RC-100

SERVICE NOTES *First Edition*

CIRCUIT DIAGRAM

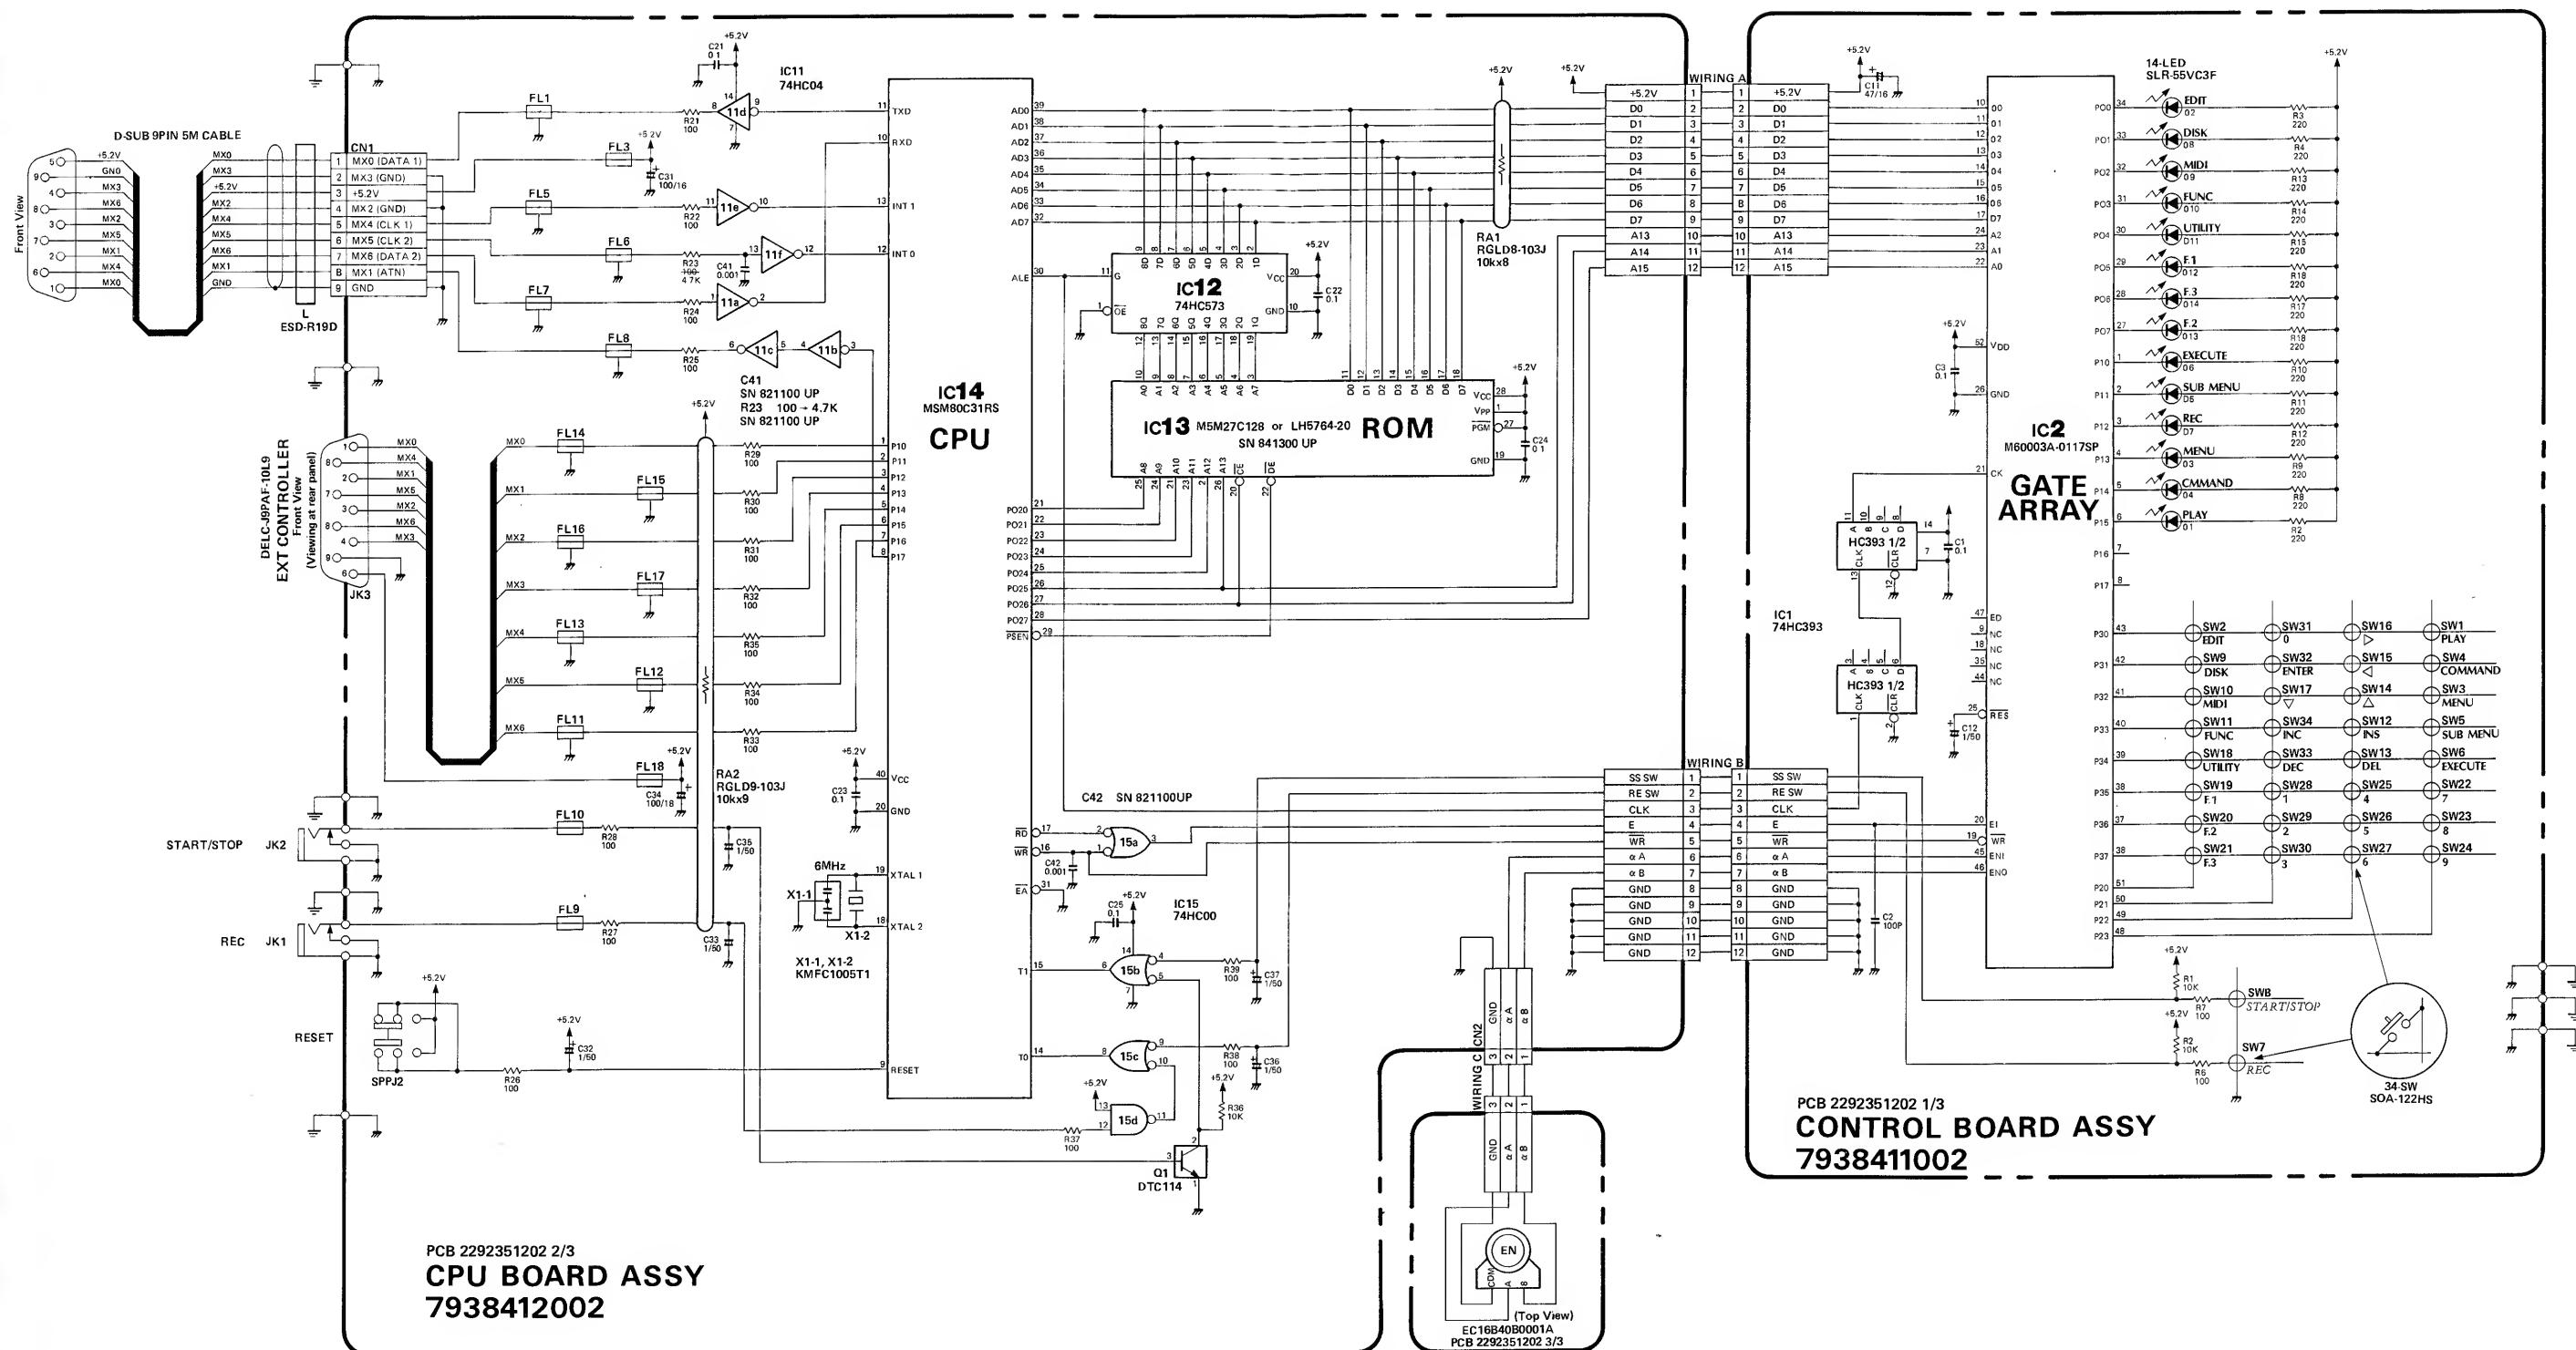
CHANGE INFORMATION

PROM IC13 CPU Board

From EP-ROM M5M27C128-2 to compatible One Time P-ROM (OTP-ROM) LH5764-20.

Eff. SN841300

Data Line Filter

From ESD-R-25D to smaller size ESD-R-19D (compatible)

Eff. SN841300

C41, C42 and R23 CPU Board

Add two 0.001 μ F capacitors and increase R23 to 4.7k Ω to prevent accumulation of statics, which causes the CPU to go hangup.

Note that the CPU can escape hangup status when RESET switch is pressed.

Eff. SN821100

Replacement: OTP-ROM LH5764-20 (PN 15179855) only.

Replacement: ESD-R-19D (PN 12449299) only.
